**Evaluation of Environmental Shadow Flicker
Analysis for “Dutch Hill Wind Power Project”**

R.H. Bolton
January 30, 2007
Rev. 1b

UPC Wind's has proposed two wind farms for Cohocton, the Cohocton Wind Power Project is first, the Dutch Hill Wind Power Project is the second. A DEIS for the Dutch Hill Wind Power Project has been submitted that includes a shadow flicker impact study (Ref. 1)

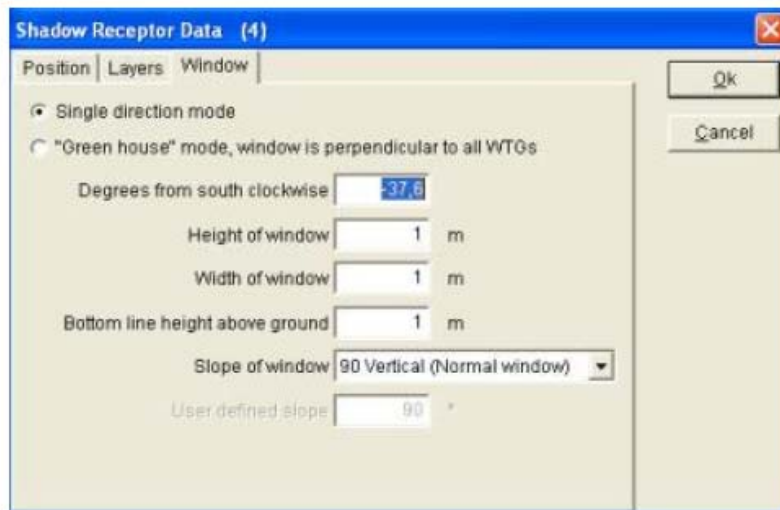
This modeling approach is not at all a “near worst case” analysis and is indeed a minimal case analysis because it only assumes shadow flicker is a nuisance if it occurs on a home

window. Then only a minimal 1 m² (about 3'x3') window at each receptor is selected, ignoring shadow effects on the residence as a whole or property.

Fig. 1: Iso-Shadow Plot Segment

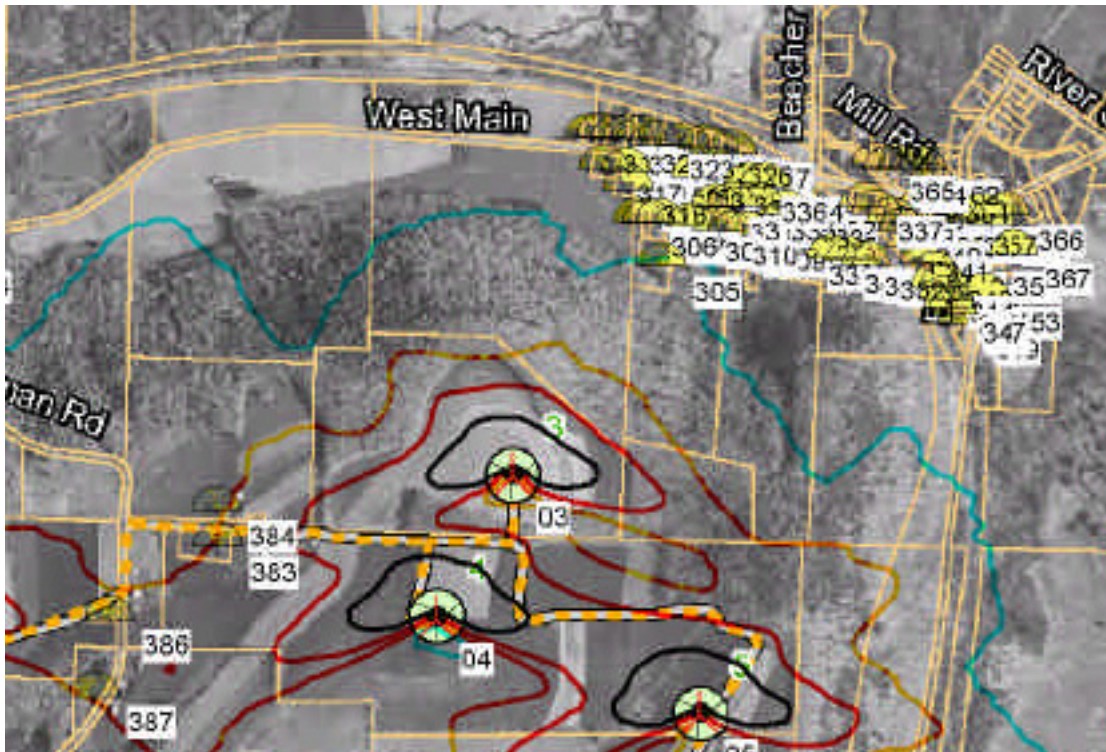
A much better picture of the shadowing extent is given by an iso-line plot of shadows which WEI has WindPro output for various sections of the project. An

example for Atlanta and Dutch Hill is shown below in Fig. 1. The quality of the plot in the WindPro output is rather poor so a decisive reading is difficult. Turbine #3 on Dutch Hill is shown to be about ½ mile from downtown Atlanta and according to the WindPro plot no shadowing will occur there. As will be discussed below in Section 4.3 however a simple benchmark computation for a ridgeline turbine shows that shadows can easily extend 2 to 4 miles. And for Atlanta the effects will last about an hour every morning. The entire hamlet of Atlanta it will likely be significantly impacted by turbine #3, #4 and #5 shadow flicker.

Fig. 2: Observer Close to Blades

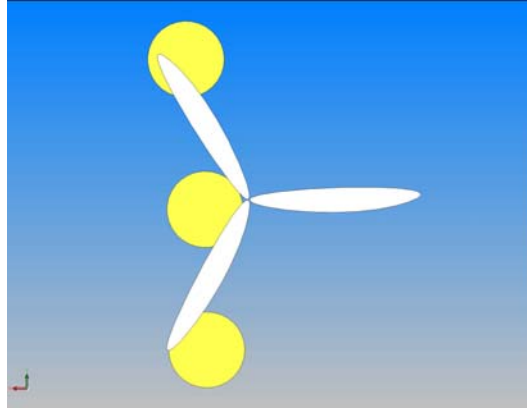
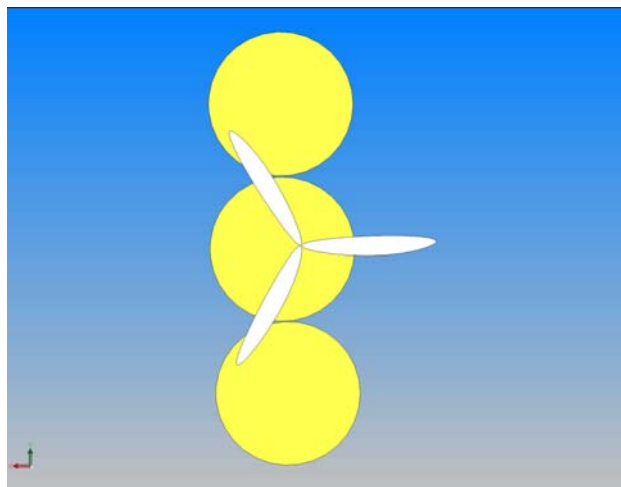
WEI does not indicate its familiarity with WindPro software nor any benchmark field tests it's ever performed to authenticate or bracket its predictions. We are therefore to believe that the software is written correctly, tested for accuracy by the authors and that WEI has setup and operated WindPro correctly. Any seasoned engineer quickly learns that modeling software must be very carefully used and verified to engender confidence and error sensitivity. At a minimum some crude benchmark calculations have to made by conventional means, which will now be done. To calculate blade flicker the propagation distances can easily be checked. The sun is a very distant object and always has nearly the same angular subtense of about 11 mrad (milliradians) to an observer. When looking through turbine blades toward the sun, the size of the visual impact depends on distance between the observer and the turbine. Thus if the observer is very close to the turbine blades the blades will be large in comparison with the sun, as illustrated in Fig. 2 below. As the observer-to-blade distance increases the proportion of the blades covering the sun decreases as shown in Fig.3.

Using this information some simple distance calculations can be done. For example when the blades just cover the sun they will occupy an angle of 11 mrad. The 3-blade diameter for the 2.5 MW Liberty Clipper turbines is about 300 ft. Using simple geometry the distance the observer would be for the sun to just cover 300 ft. is $300' / 11 \text{ mrad} = 27,000 \text{ ft.}$, or 5 miles. This very long distance can only occur when the sun is at a low angle over the horizon.

Fig. 4: Shadow Geometry

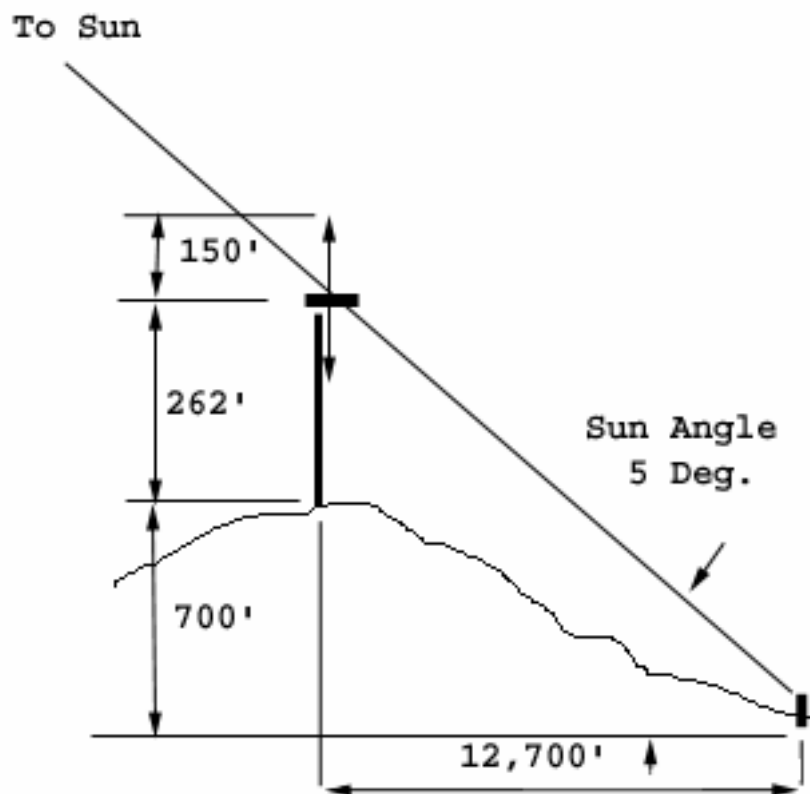
As WindPro states, it calculates a 4.8 km (15,600') observation distance for a 45 m (150') diameter disk, ½ the size of the much larger Liberty units. Contrary to WindPro's flat-terrain assumptions, turbines on elevated ridgelines will cast very long shadows into the adjacent valleys because the sun will rise much higher in the sky. For a 700' high north-south ridgeline (eg Dutch Hill towering over Atlanta) and a 262' high nacelle the 300' diameter rotors will cast over a 2 mile shadow when the sun is at 5 degrees. This calculation is illustrated in Fig. 4 below.

The flickering turbine shadow will be seen in the valley below the ridgeline shadow. Ridgeline shadows easily cast very long shadows as is well known to anyone living in a situation like this. For example the author frequently experiences the well defined ridgeline shadow of Bare Hill cast on opposing Johnson Hill across Canandaigua Lake, over a mile distant.
